ATTENDANCE LIST
PUBLIC MEETING FOR CO-OYT-0629

RE: FISHERS CANYON DRAINAGE PLANNING STUDY DATED JANUARY 16, 1991

FINAL PROPOSED LIST OF CATEGORIES OF ACTIVITIES AND PROPOSED LETTER OF PERMISSION PROCEDURES

**FISHERS CANYON
 DRAINAGE BASIN PLANNING STUDY**

Proposed List of Categories of Activities
 No. CO-OYT-0618 for Fishers Cnyon DBPS
 near Colorado Springs, El Paso County, CO
 Sheet 2 of 4
 January 1991

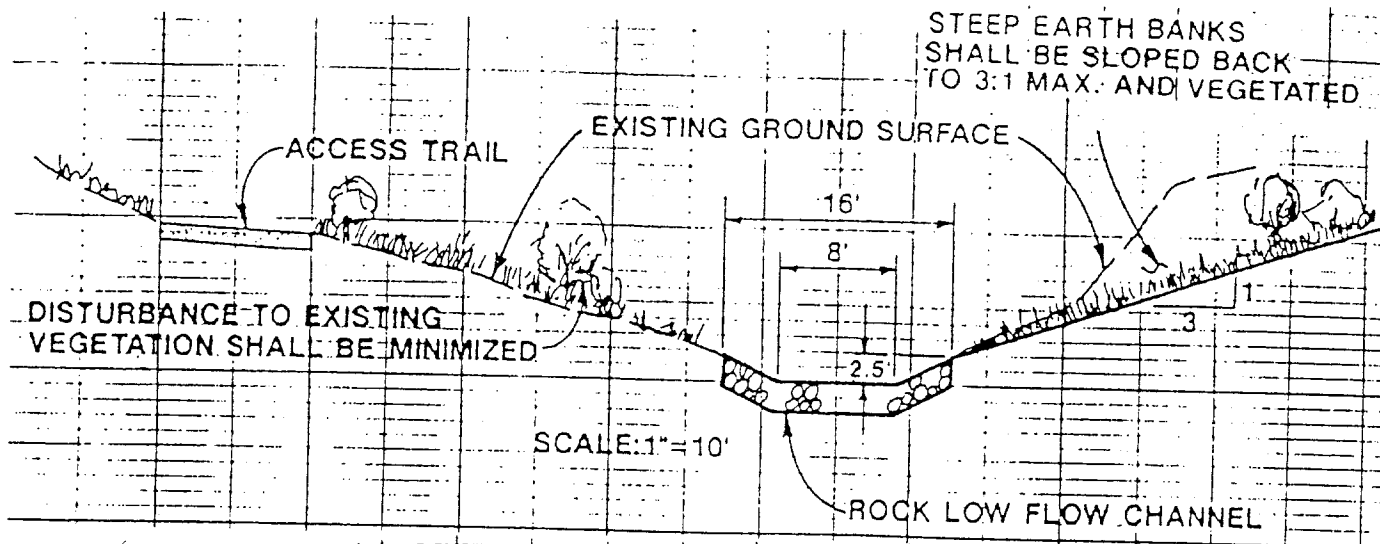
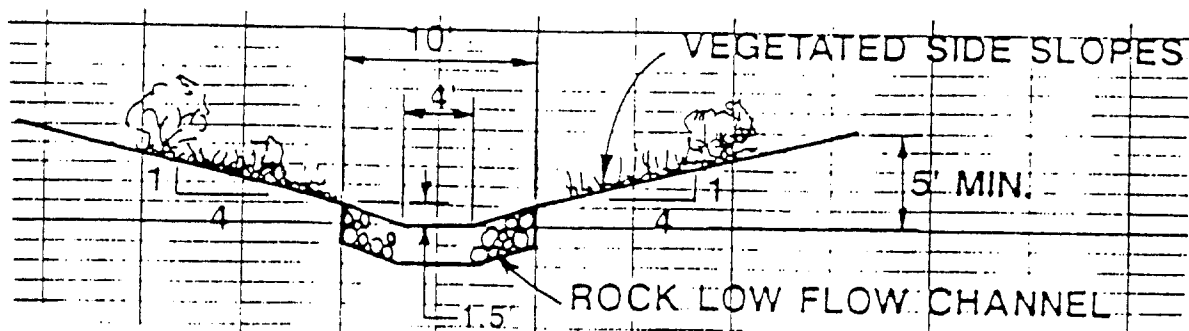
a. Based upon the Flood Insurance Study for El Paso County, Colorado, and Sheet 2 of 4 of the public notice, the recommended storm sewer improvements for Stratmoor Valley North are within the boundaries of the 100-year flood plain. Effects of inundation by the 100-year flood should be considered in the design of the system.

The comments presented from your Engineering and Planning Division are valid ones that will clearly be addressed at the time of final design of specific improvements. The effects of the 100 year floodplain upon the Stratmoor Valley North Storm Sewer will be considered in design, as appropriate; the intent of this system is to primarily provide protection for the more frequent lower recurrence interval storm events. Similarly, Fountain Creek velocities and backwater depths should be considered, for the design storm frequency, for all outfall storm water systems. Concerning Item C., El Paso County is cognizant of the present floodplain regulations and all proposed improvements will have such considered in their design and construction. However, the Regional Floodplain Administrator is primarily responsible for the implementation of our floodplain regulations.
